Re: Revised Work Plan
Cabot Carbon Site, Gainesville Florida

**Revised Supplemental Groundwater Quality
Characterization Work Plan**

**Cabot Carbon/Koppers
Superfund Site
Gainesville, Florida**

FIGURE 1

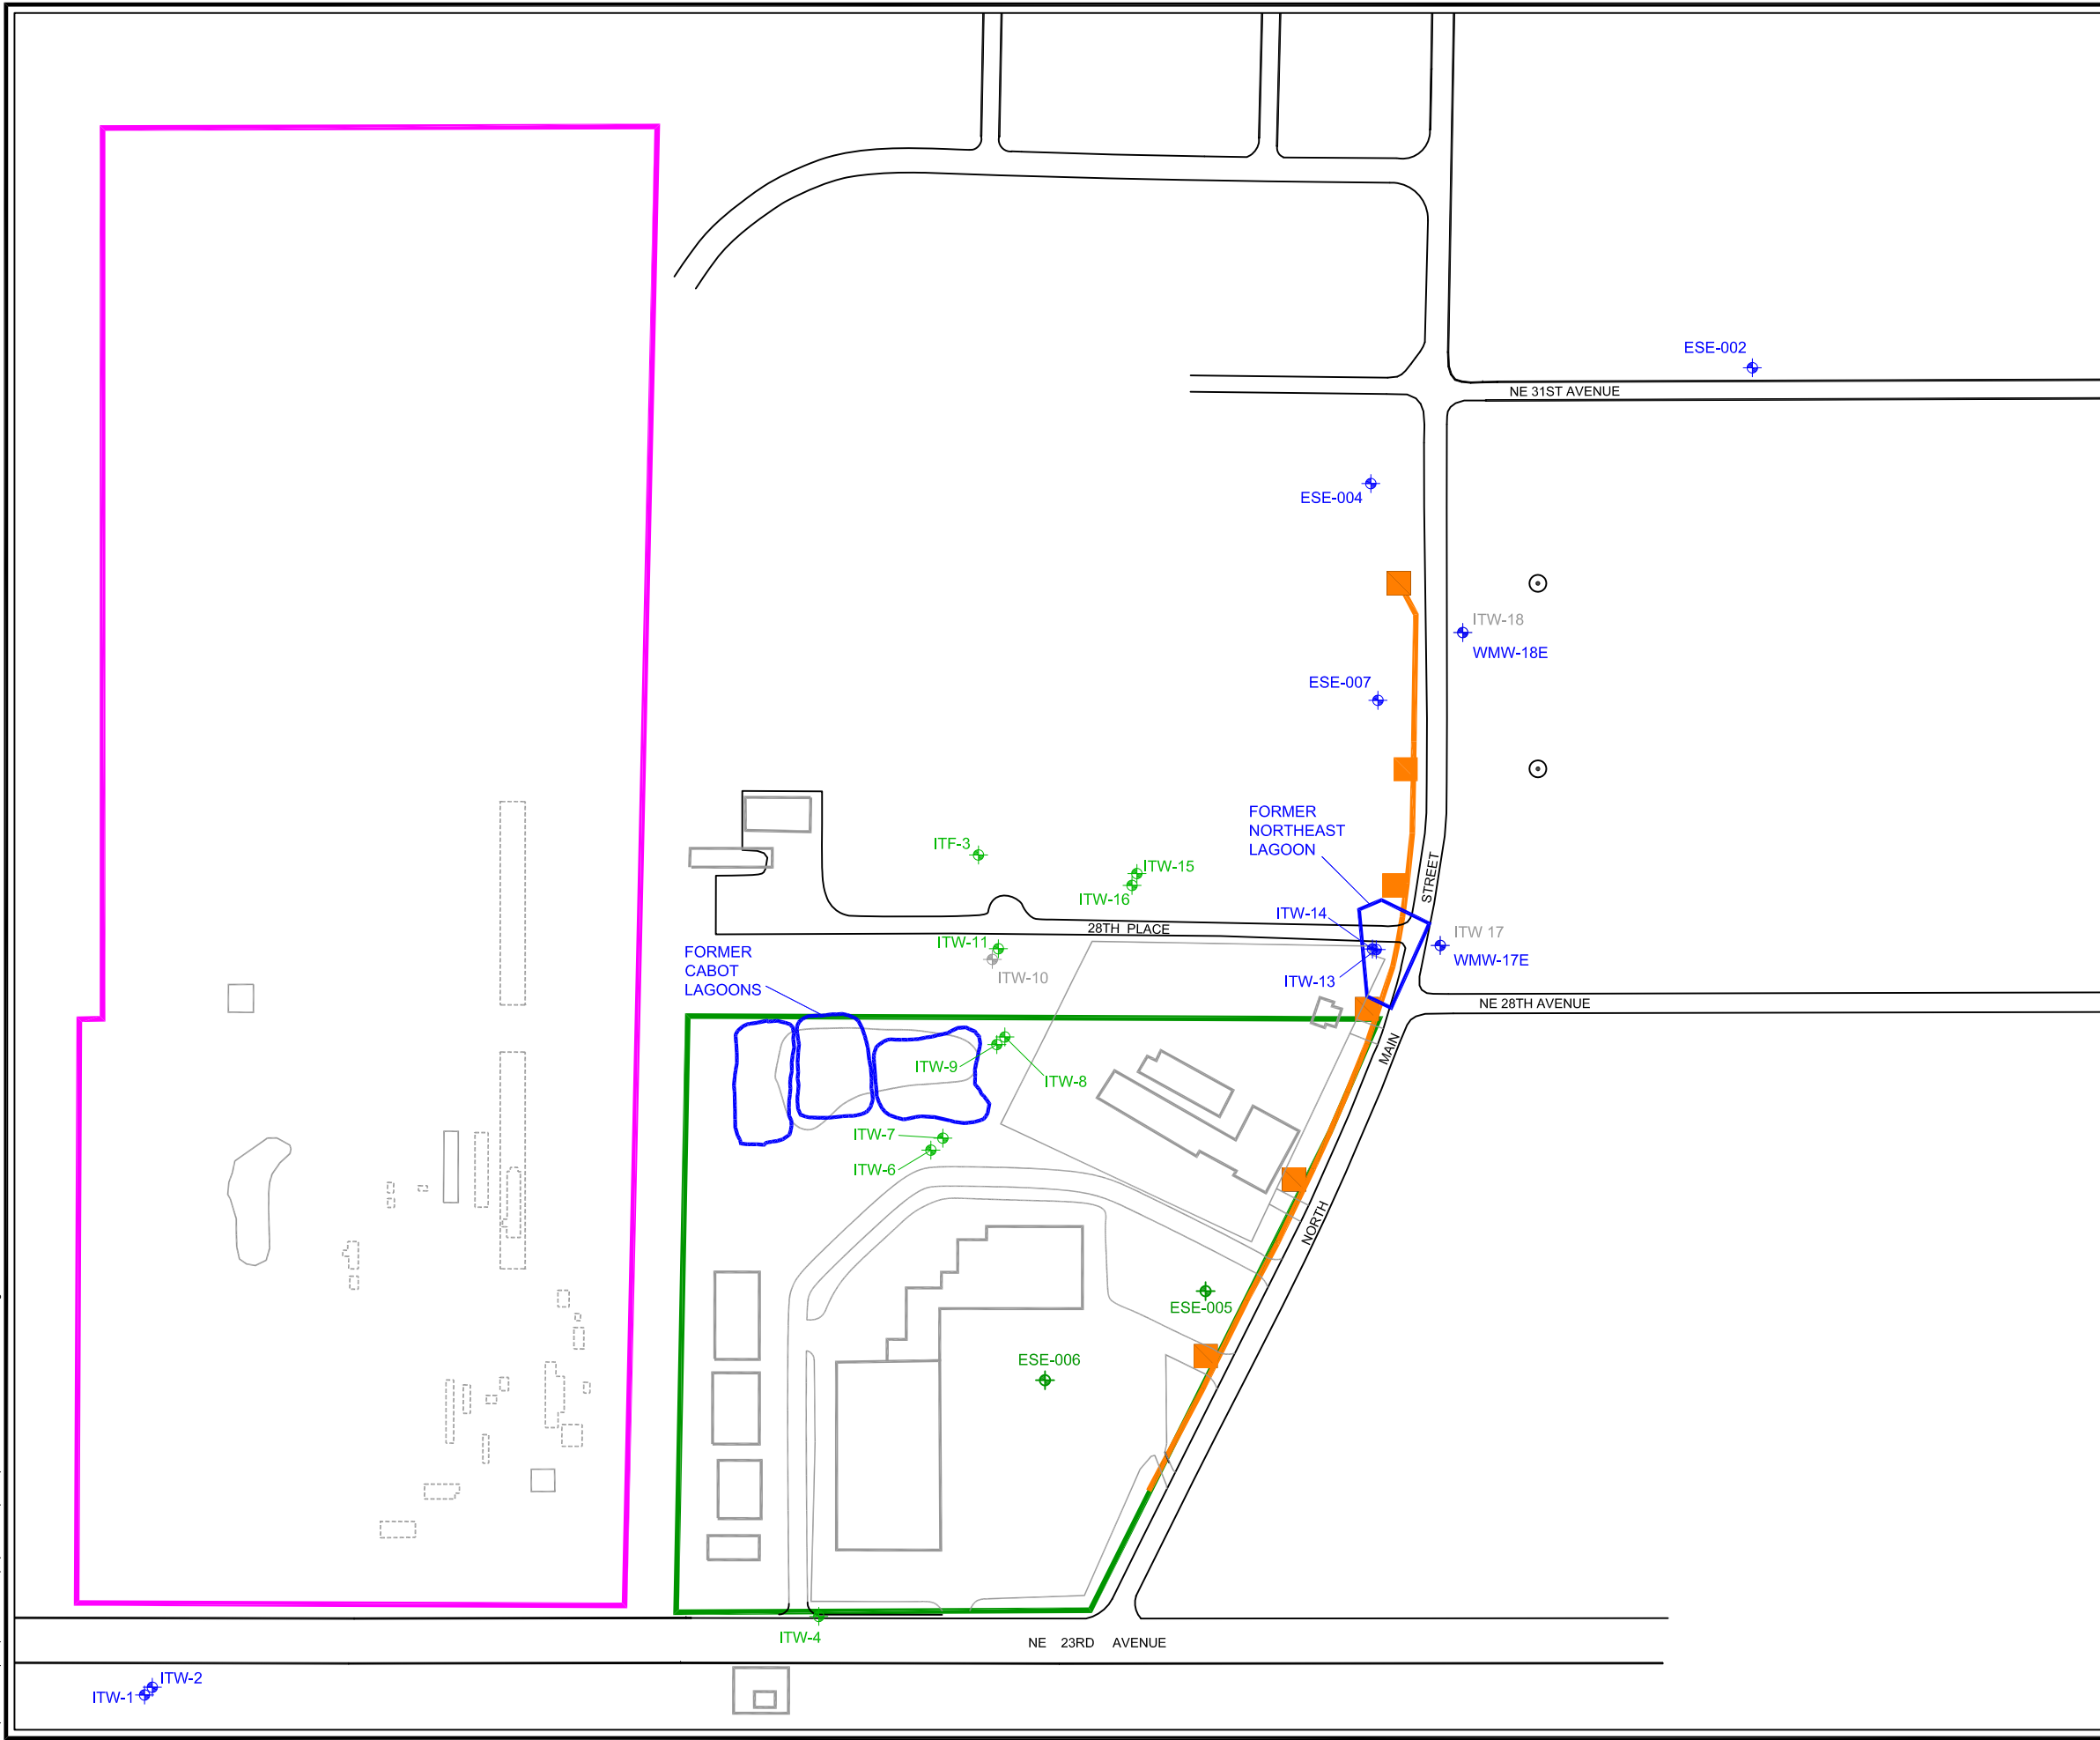
Issue: Following the five-year review of the Site, USEPA had requested that groundwater quality be characterized at all monitoring wells, located east of the Koppers property and in the vicinity of the former Cabot lagoons, to determine if the lagoons are a continuing source of contamination. In the February 29, 2008 letter, USEPA also requested that wells ESE-005 and ESE-006 be added to Cabot's proposed list of monitoring wells and that surficial aquifer wells showing significant Cabot-related contamination be analyzed for pine tar indicator compounds.

Cabot will perform vertical groundwater profiling at two locations on the automobile dealership property located downgradient of the interceptor trench (see Figure 1). The two locations were selected so that they are hydraulically downgradient of the former Cabot lagoons, but not in the vicinity of the Northeast Lagoon, which was not associated with former Cabot operations⁵. To avoid the stagnation zone expected in the immediate vicinity of the trench and demonstrate that the trench is effectively protecting downgradient receptors, groundwater profiling will be done at locations approximately 200 to 300 feet east of the trench. Also, sampling will not be performed along the southern portion of the trench (south of the Northeast Lagoon), since no Cabot-related contamination was detected upgradient of this area on the former Cabot property.

Discussion and Proposed Action: Data collected in the surficial aquifer near the former Cabot lagoons show low soil concentrations that declined with depth and groundwater concentrations that have declined over time and have not exceeded the groundwater cleanup goal for phenol in over 10 years (Cabot, 2006)³. Therefore, a review of available data strongly indicate that the lagoons are not a continuing source of contamination. However, per EPA's request, Cabot will perform a one-time expanded groundwater monitoring event, similar to that performed in March 2005. This sampling round will characterize current groundwater quality in the surficial aquifer in the vicinity of the Cabot lagoons and downgradient areas. Per EPA's request, Cabot will also include monitoring wells ESE-005 and ESE-006 to the sampling event. Therefore, the quarterly sampling event will be expanded to include a total of 20 monitoring wells located east of the Koppers property (9 routinely sampled and 11 additional wells; see Figure 1 and Table 1).

FIGURE 2

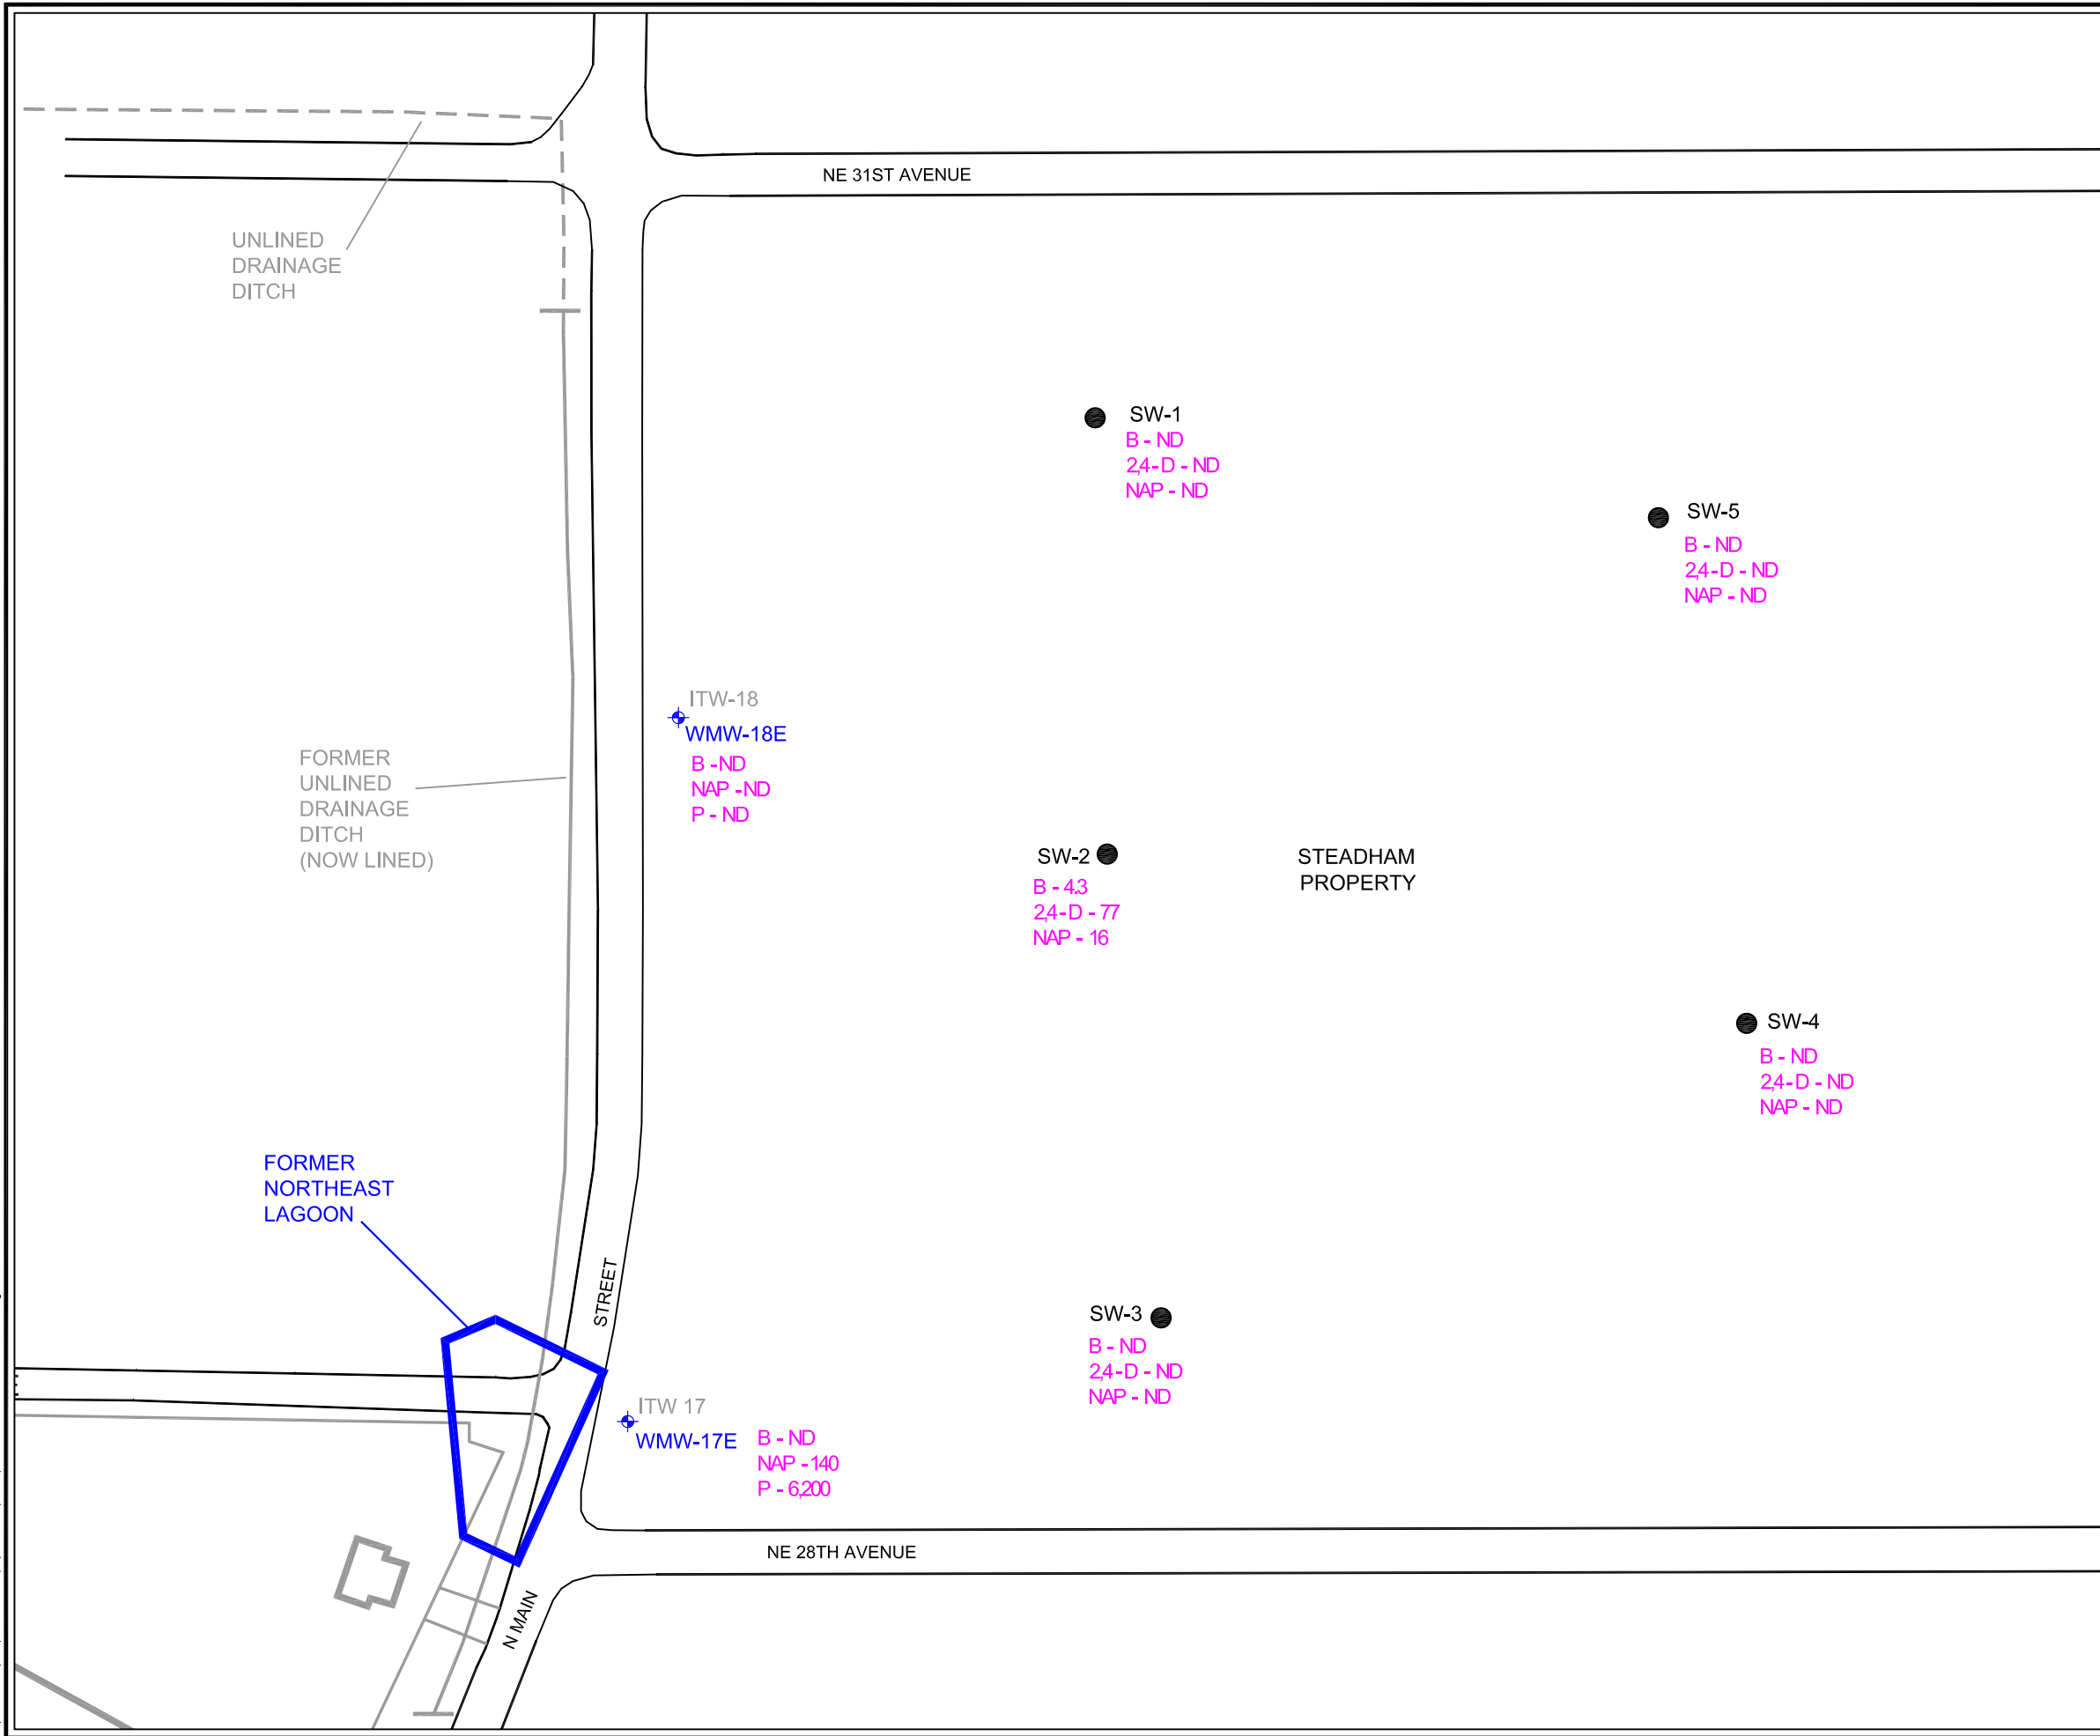
Issue: USEPA raised concern regarding the effectiveness of the Cabot interceptor trench to capture contaminated groundwater at the base of the surficial aquifer and requested that Cabot perform depth-discrete profiling of water quality to demonstrate trench effectiveness.

- A review of pre-remedy groundwater quality data collected on the former Cabot property and at the adjacent Steadham property (located east and downgradient of North Main Street) indicated that the pre-remedy lateral extent of the groundwater plume was limited and clearly defined (see Figure 2). The highest pre-remedy groundwater concentrations, east of North Main Street, were detected at ITW-17, which was located immediately downgradient of the Northeast Lagoon. Although low concentrations were detected at SW-2, located on the Steadham Property and to the northeast of ITW-17, it is not clear whether these were associated with the former Cabot property. No site-related contaminants were detected at any other monitoring wells east of North Main Street, including ITW-18. This may be attributed to the historical drainage ditch along North Main Street that intercepted a vast majority of shallow groundwater and prevented off-Site migration (Figure 2). Therefore, even prior to trench installation, the groundwater plume was localized to the ITW-17 area.
